UNITED STATES PATENT AND TRADEMARK OFFICE

APPLICATION NO.	FILING DATE	FIRST NAMED INVENTOR	ATTORNEY DOCKET NO.	CONFIRMATION NO.
10/731,612	12/09/2003	Jeffrey M. Dils	10710-623 (PTG 0633 PUS2)	4771
757	7590	11/13/2006	EXAMINER	
BRINKS HOFER GILSON & LIONE P.O. BOX 10395 CHICAGO, IL 60610			NGUYEN, PHONG H	
			ART UNIT	PAPER NUMBER
			3724

Office Action Summary	Application No. 10/731,612	Applicant(s) ^{NR} DILS ET AL.	
	Examiner Phong H. Nguyen	Art Unit 3724

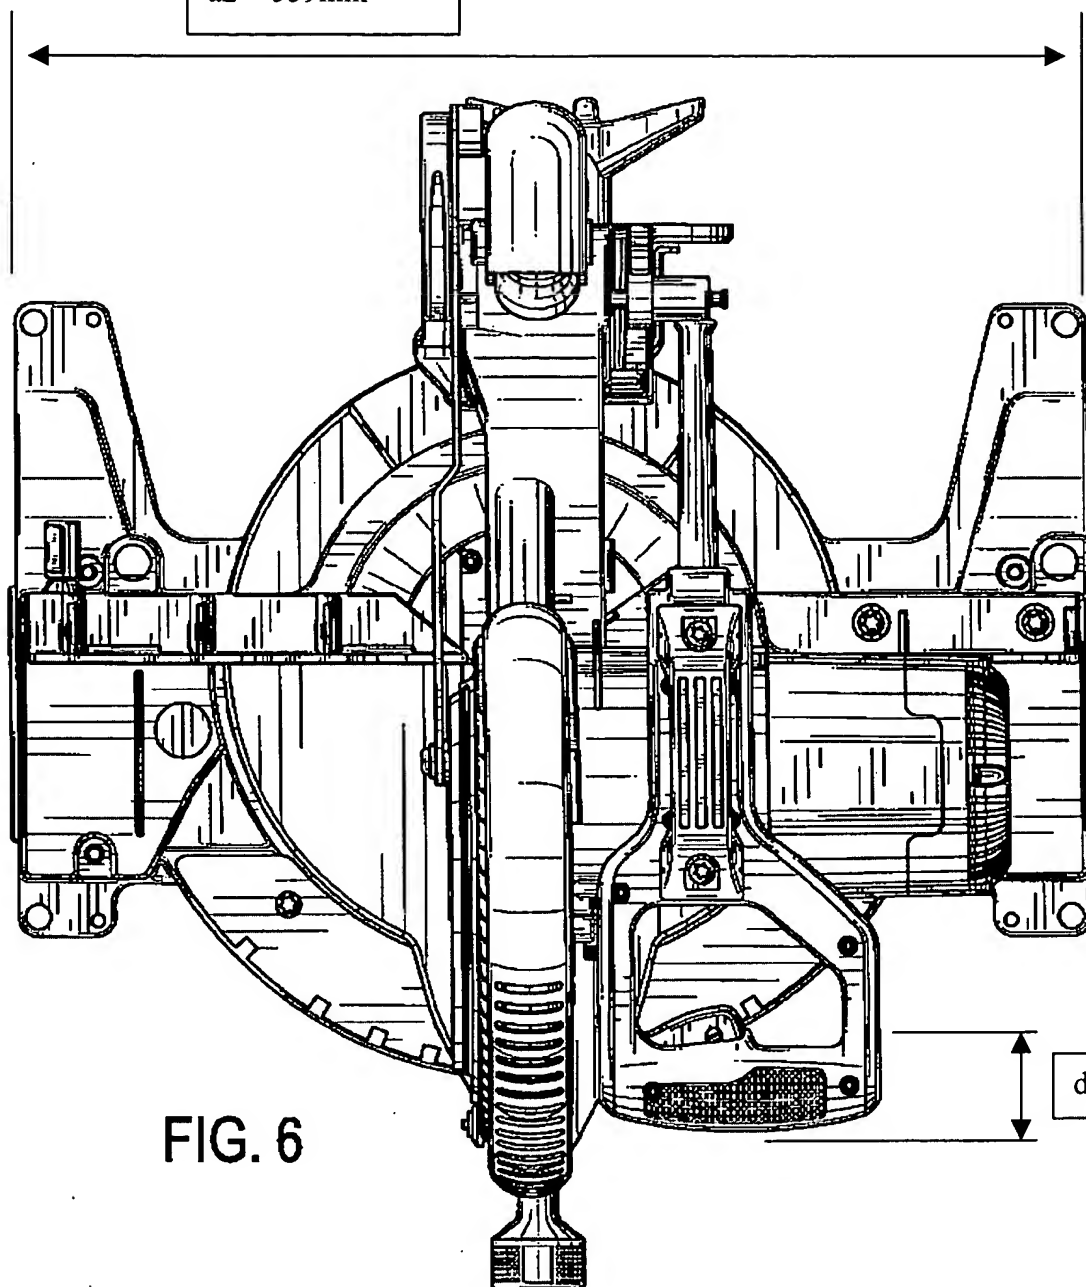
Bean teaches a miter saw comprising a base, an arm assembly having a handle. The handle comprises a gripping portion and a palm pad portion. See Figs. 1-7. The following paragraphs are the Examiner's interpretations of Bean's handle:

The distant (a1) in Fig. 6 is 120 mm. The distant (a2) of a real miter saw is about 559mm, which is 22 inches. Therefore, the scale of Fig. 6 with respect to the real miter saw is $a1/a2 = 120/559 = 1/5$.

a1 = 120mm
a2 = 559mm

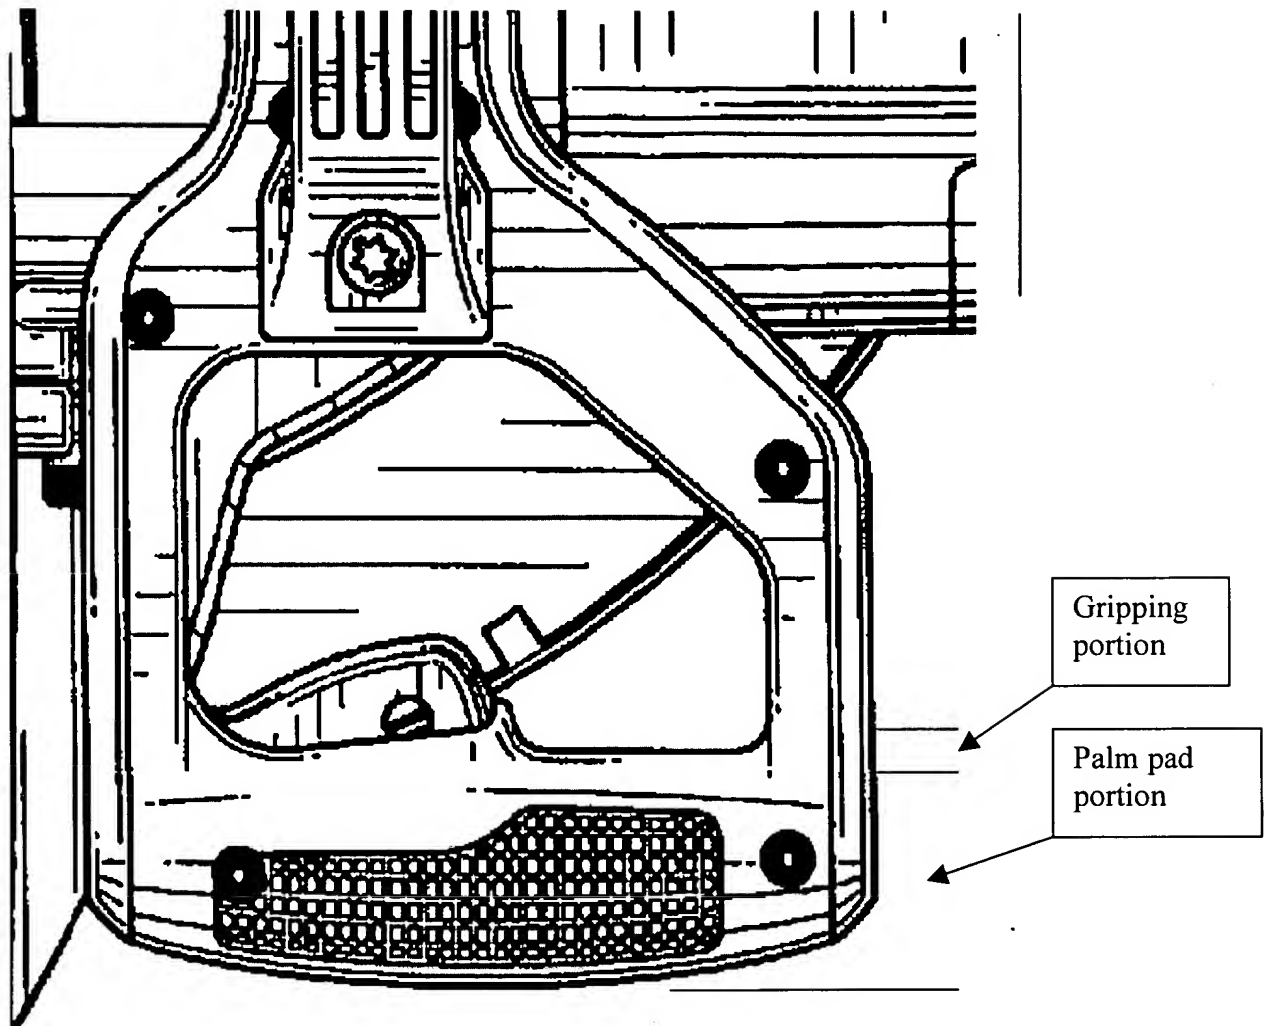
Having the width of the handle being $d1 = 10$ mm and the scale being $1/5$, the distant (d2) of a real miter is $10 \text{ mm} \times 5 = 50$ mm, which is 2 inches.

The length of a palm of an adult person is 3-4 inches. The heel portion as defined in Fig. 3 of the Applicant's disclosure is $3/4$ the length of the palm measured from the base of the fingers to the wrist. Therefore, the heel portion has a length about 3

inches. Since the Bean's handle extends into the palm's area defined as the heel portion,

Bean meets the limitation (c).
